# PHASE VI LANDFILL
# PERMIT MODIFICATION
# RIDEM FRESHWATER WETLANDS
# REQUEST FOR A PRELIMINARY DETERMINATION
# CENTRAL LANDFILL

## 65 SHUN PIKE
## JOHNSTON, RHODE ISLAND

**JANUARY, 2014**

1. This plan set includes only sheets which are part of the "Phase VI Permit Modification to the RIDEM Freshwater Wetlands Request for a Preliminary Determination", Brown and Caldwell January 2014. Some sheets in this set refer to one or more sheets in the original approved plan set: "RIDEM Freshwater Wetlands Request for a Preliminary Determination", Pare June 2009. Sheets in this plan set which include an "R" in the drawing number are revised versions of the corresponding sheet of the original approved plan set. Information shown on a revised ("R") drawing supersedes information shown on the original drawing, except as noted.
2. The Limit of Revised Grading indicates the extent of grading changes made by Brown and Caldwell to the original approved plan set.

## CROSS-SECTION AT POND 13 OUTFLOW DEVICE (1 / C-9.5)

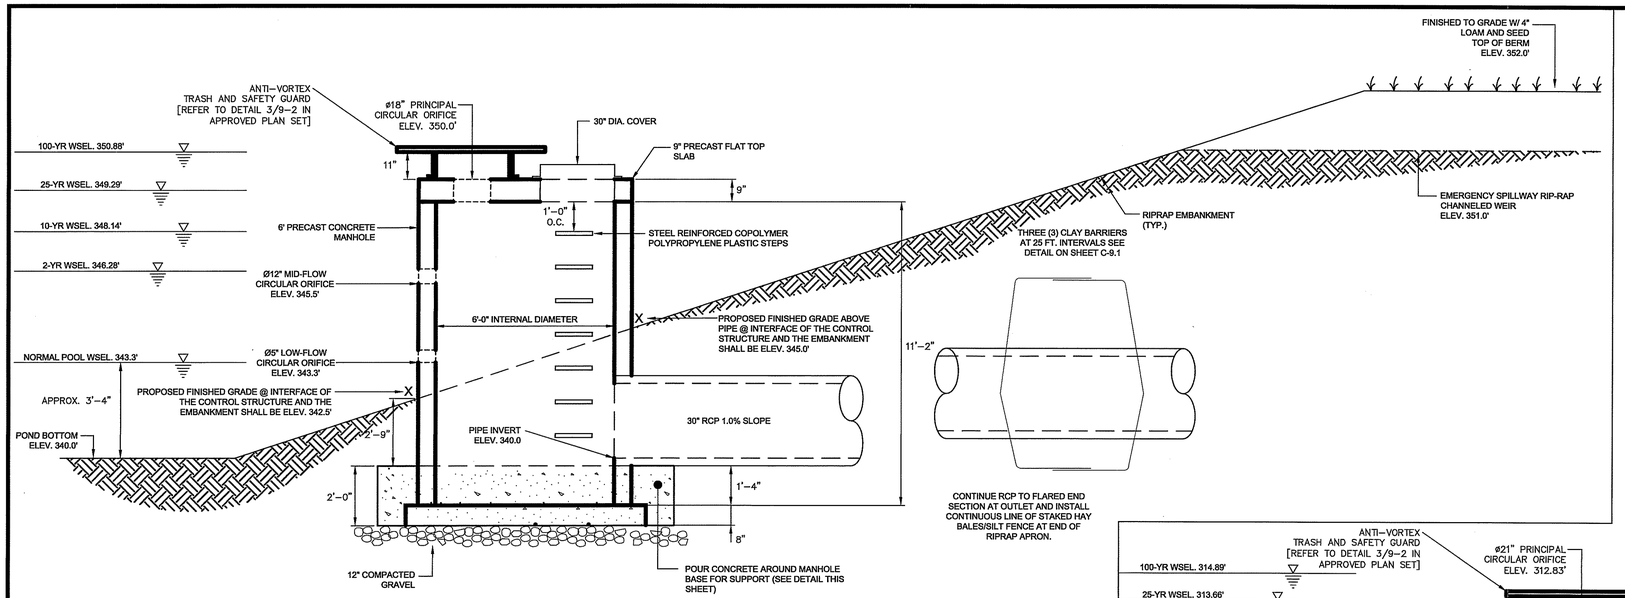
NOTE: THIS DETAIL SUPERCEDES DETAIL 1/9-1 FROM THE APPROVED APPLICATION.

## CROSS-SECTION AT POND 14 OUTFLOW DEVICE (2 / C-9.5)

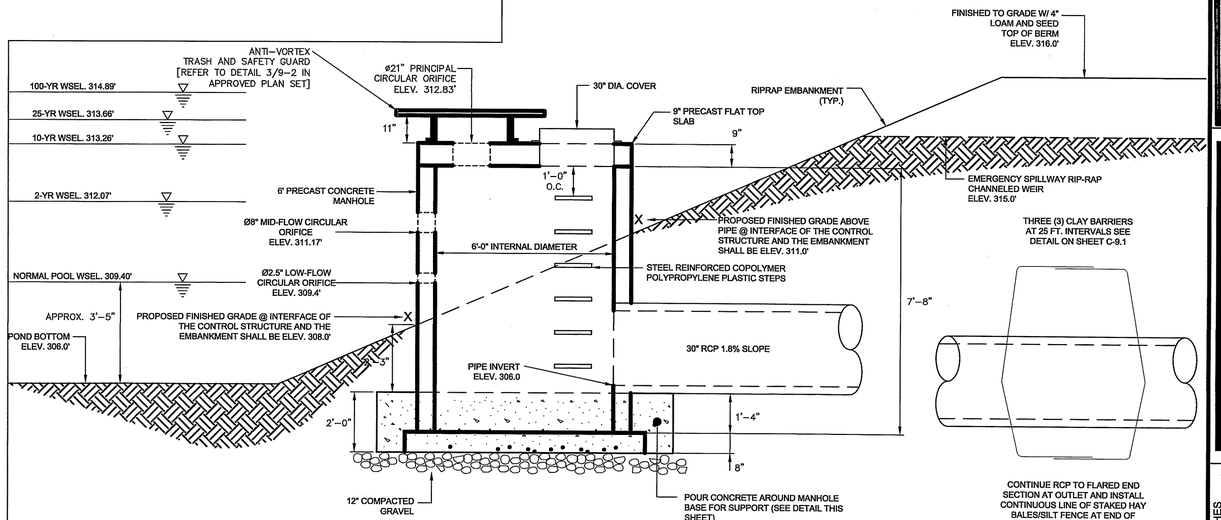
NOTE: THIS DETAIL SUPERCEDES DETAIL 2/9-1 FROM THE APPROVED APPLICATION.

## CROSS-SECTION AT POND 4 OUTFLOW DEVICE (3 / C-9.5)

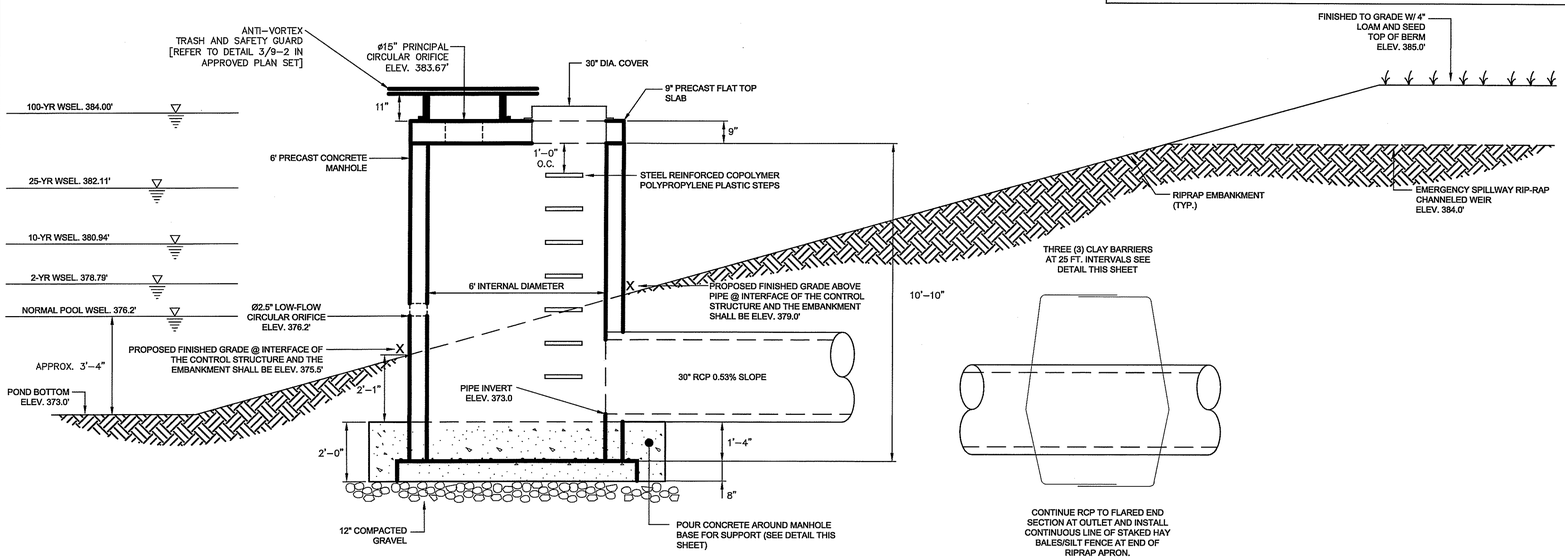
NOTE: THIS DETAIL SUPERCEDES DETAIL 8/9-2 FROM THE APPROVED APPLICATION.
